ENGINEERING BULLETIN

Improved Drain Valve For Hastings Fuel Water Separator Filters

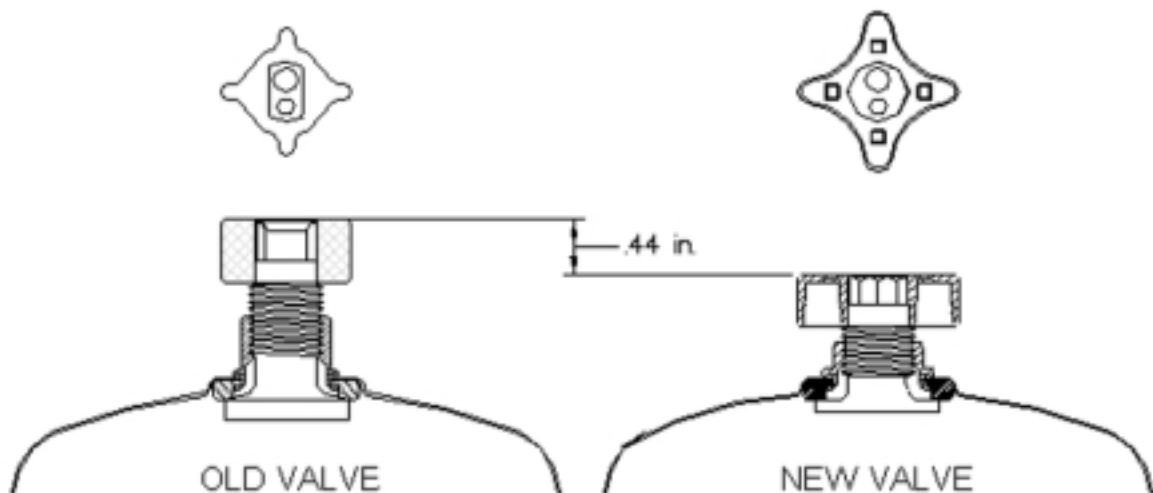
Hastings Filters is pleased to announce the introduction of a new type of drain valve for their fuel water separator line. The current valve design has been used for a number of years.

In our continuing effort to improve the product line, Hastings has recently implemented a new style of valve design.

While the new design is shorter, which allows more clearance, the main benefit will be the increased gripping area of the nut itself. We trust that this will allow the drain to be opened by hand most of the time.
